July 2, 2015  
W-P Project No. 13034B

Subject: Revised Site Plan Review Submission  
Self-Storage Facility  
Center Street, Auburn, Maine

LAKE SUPERIOR CORPORATION  
SITE PLAN REVIEW DRAWINGS FOR  
SELF STORAGE FACILITY  
AUBURN, ME

**EMERGENCY VEHICLE ACCESS**

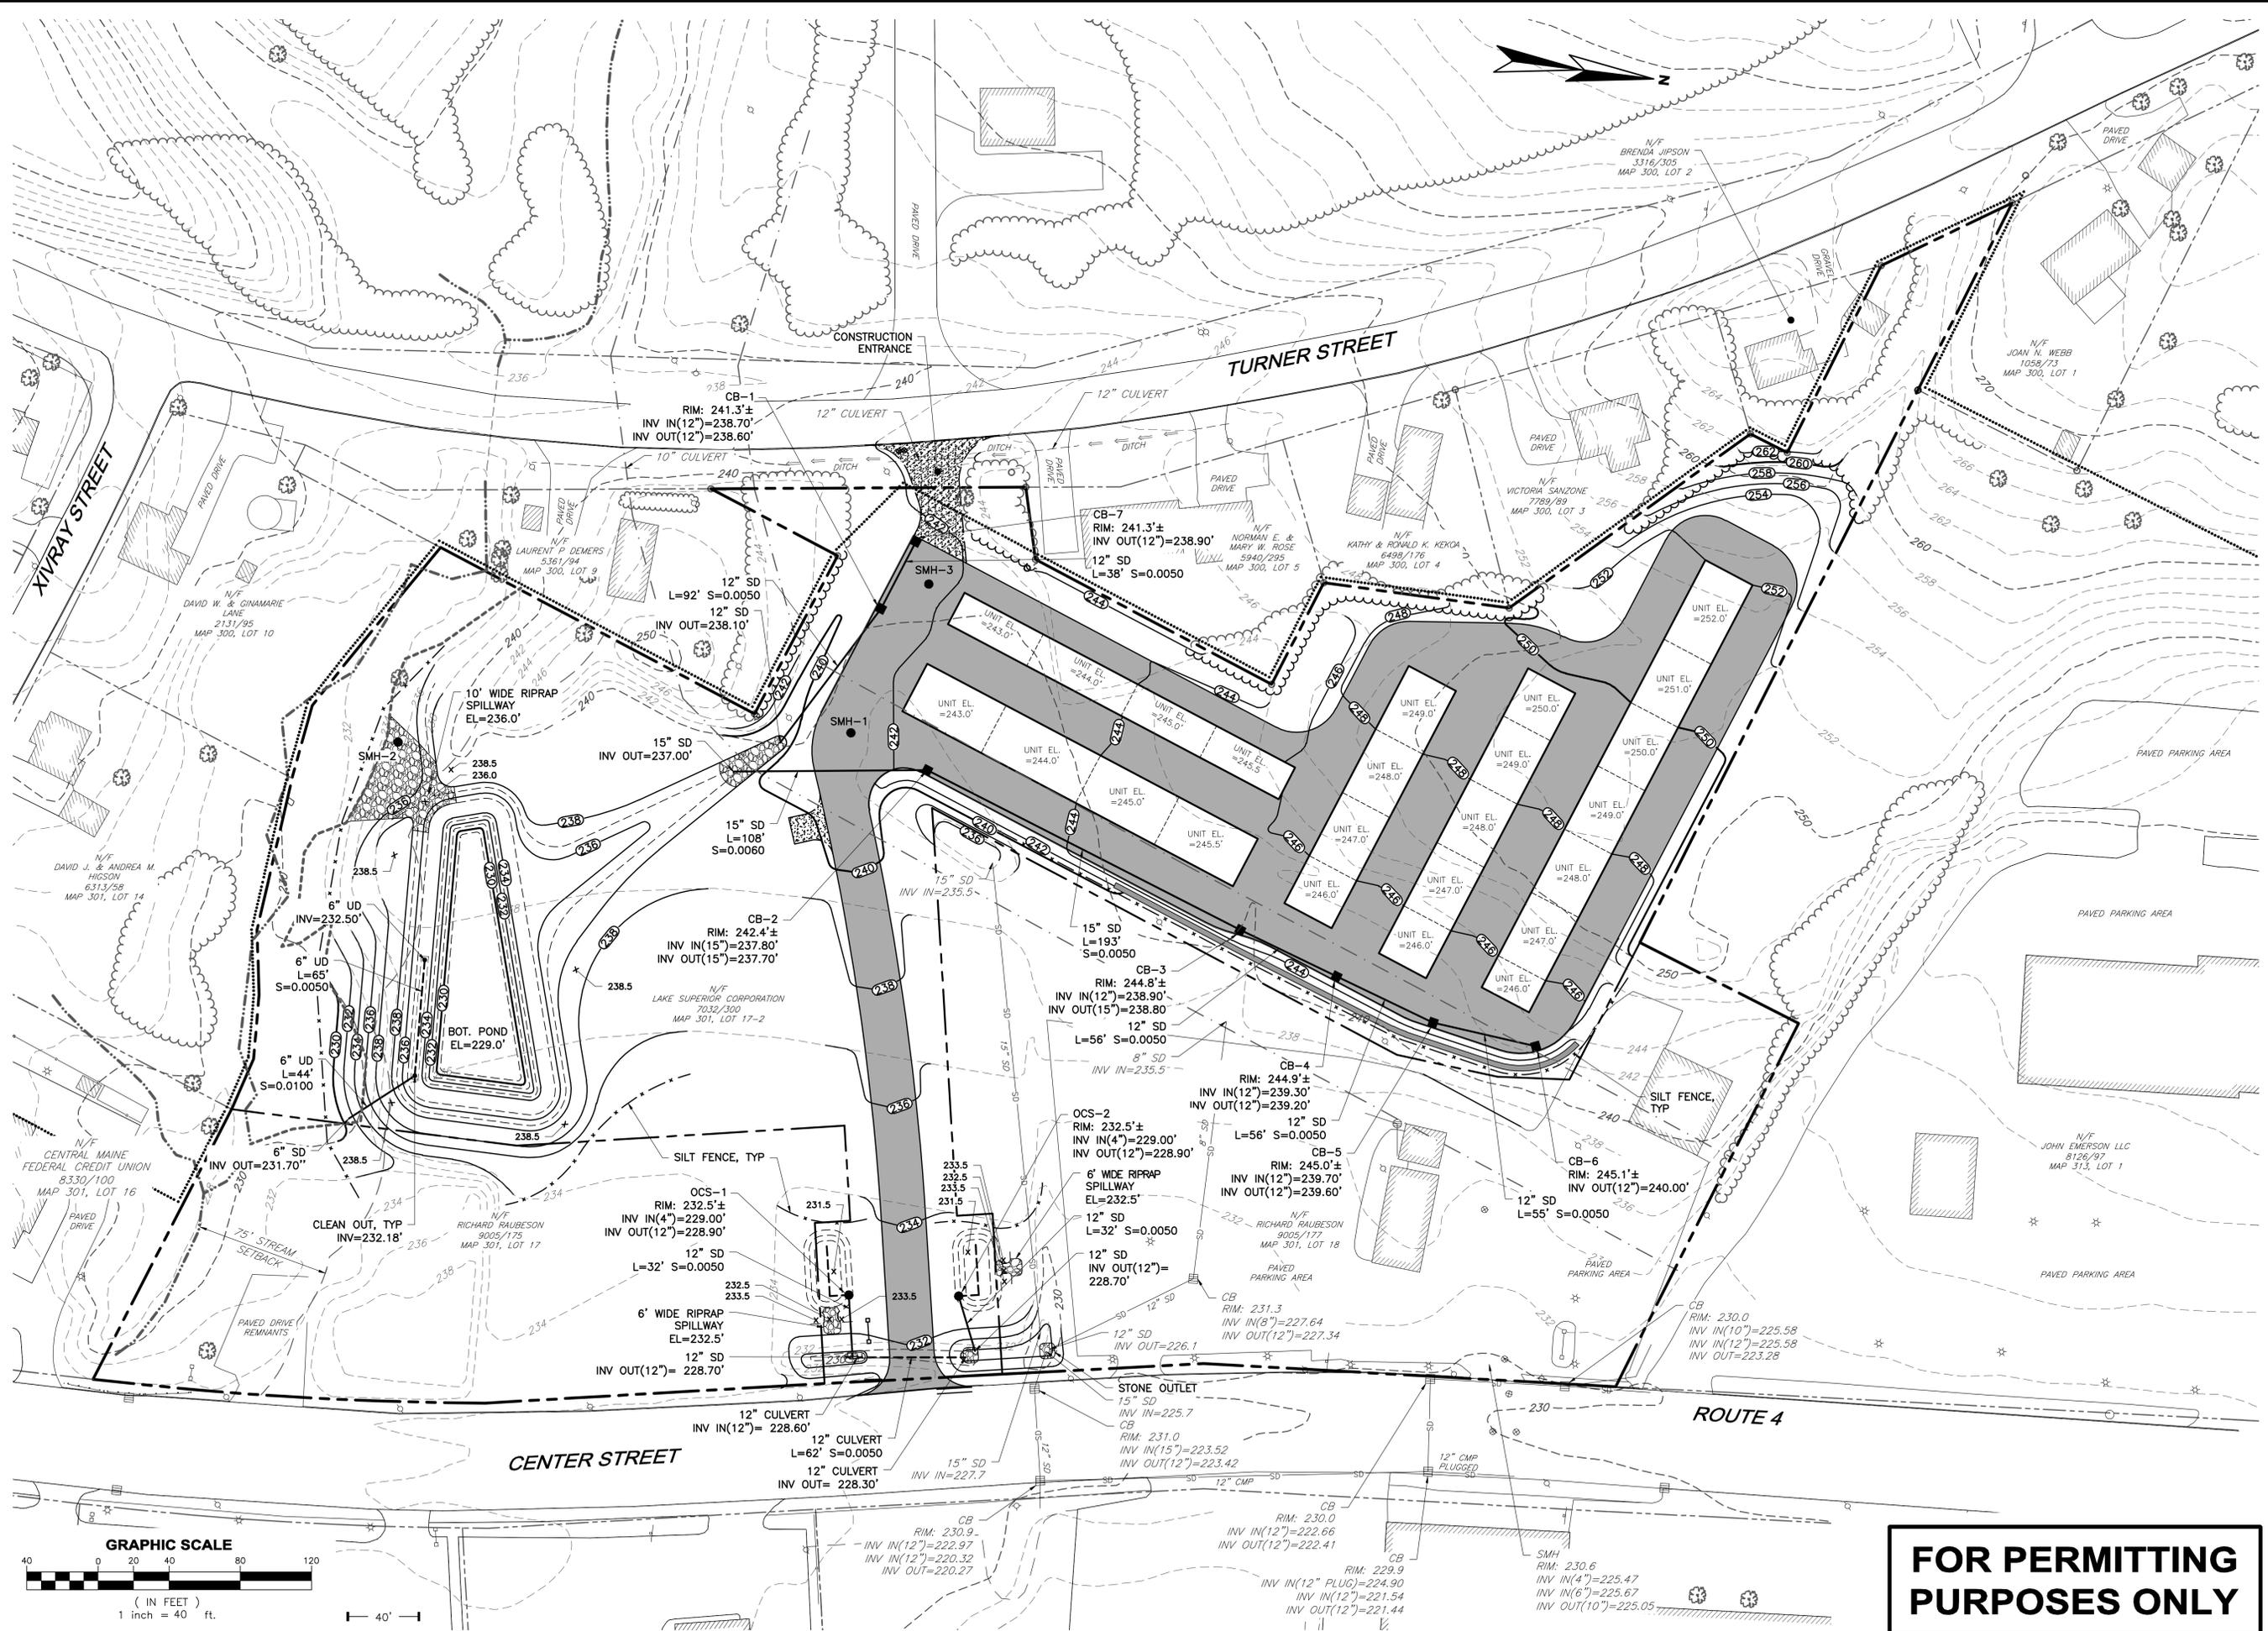
We have also included with this submission a copy of the fire truck turning movement simulation that is based on the E-One fire apparatus that is based in the Center Street Fire Station and is the likely first vehicle to respond to the site. The simulation demonstrates that the truck can circulate around the site without backing up. Once the

site is built we would encourage that the fire department confirm the maneuvering through the site with an actual test run.

PROPOSED GRADING, DRAINAGE & EROSION CONTROL PLAN  
 DRAWING  
 C-4

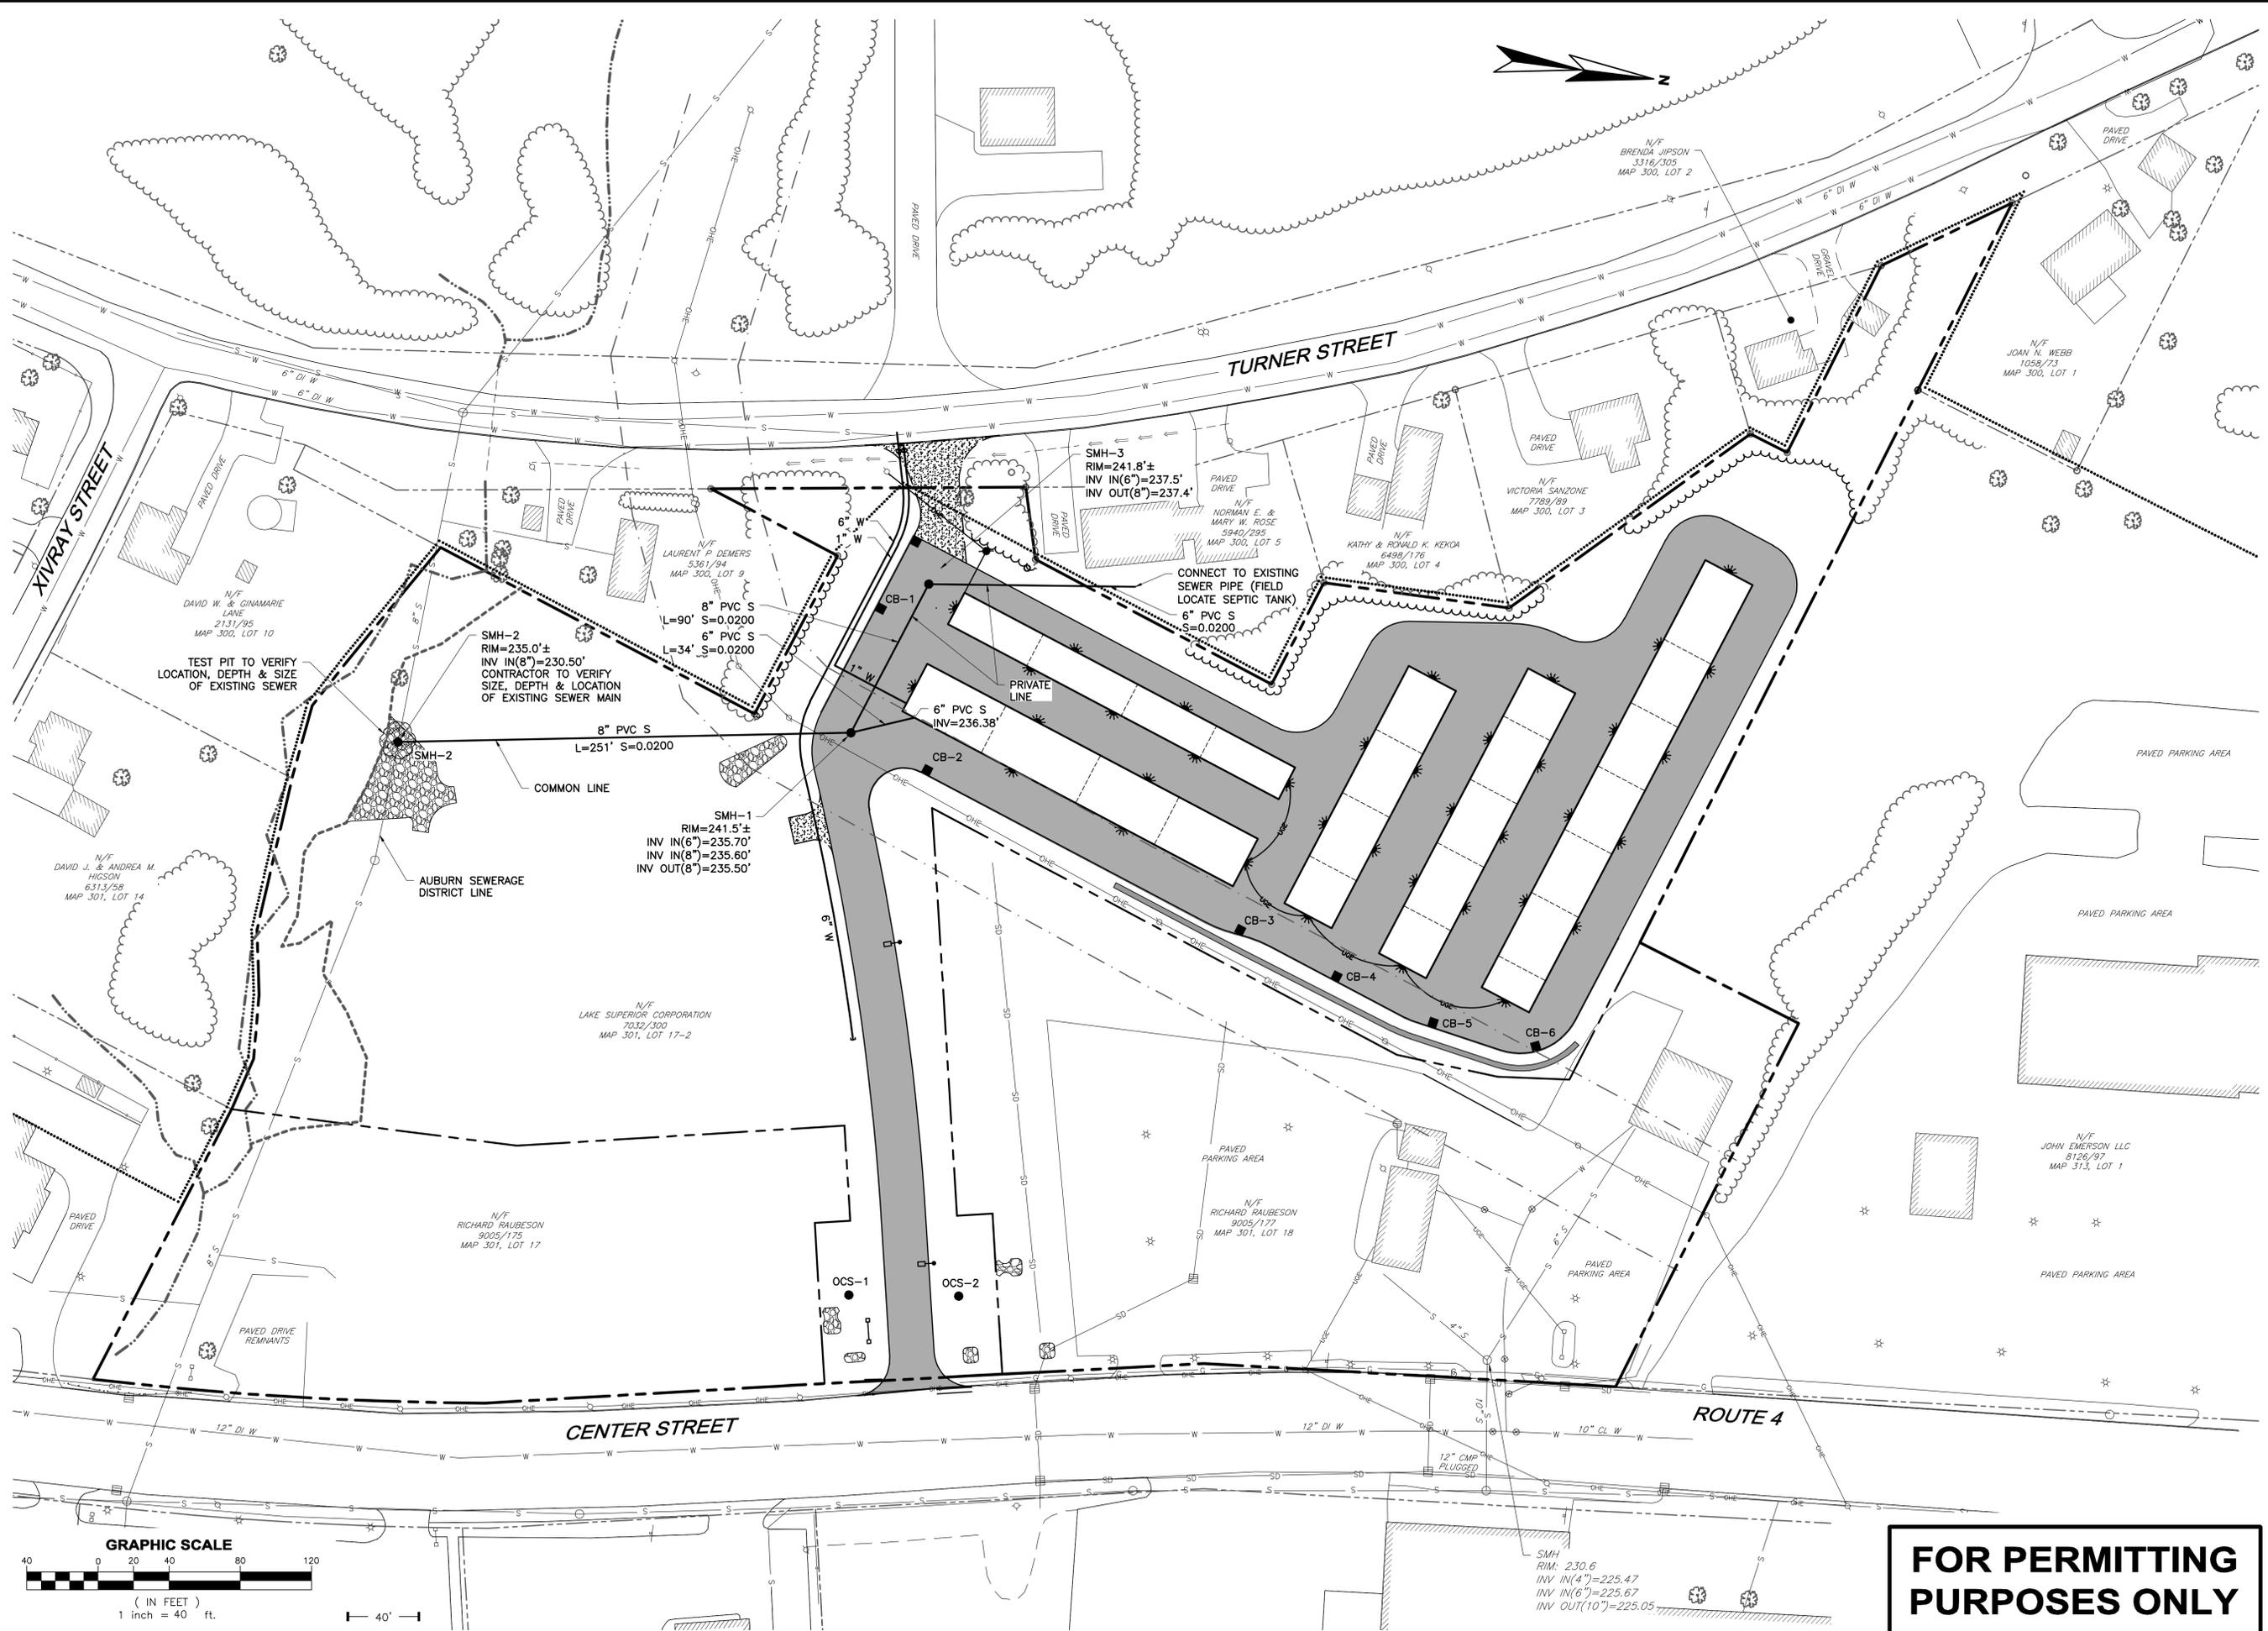
The revised site plan shows the building along the rear property line increased in depth from 15' to 20' and with a narrow 15 foot wide access aisle along the rear of the building. The building will be 35 feet from the rear property line and there will be a 20 foot wide landscaped buffer between the access aisle and the property line. In order to accommodate this revised plan, the distance between two of the buildings will be reduced from the 28 feet originally shown to 25 feet and a waiver from the 30 foot standard in Section 60-500 (3) d. is requested. The 30 foot distance cannot be achieved in this case because of the CMP pole line easement that crosses the parcel and does not allow for the building program to move closer to Center Street than is currently shown. The total building area proposed for the site is now 28,500, s.f. and the total paved area is 1.45 ac.

The revised site plan increases impervious area of the proposed project over the original site plan. To address this change we have revised the stormwater management plan to demonstrate that the proposed stormwater treatment measures will be adequate to serve the revised plan. We have attached the revised stormwater management plan.
